USSN 10/042,237
Art Unit 2644

Amendments to the Drawings

FIG. 3

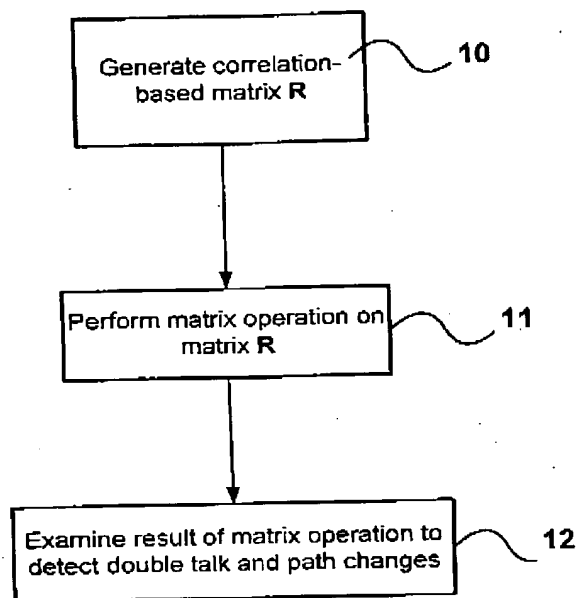
Permission is respectfully requested to replace the sheet of drawings containing Figure 3 on file with the replacement sheet submitted herewith. The newly added subject matter has been deleted in box 12 and replaced by wording taken from the specification.
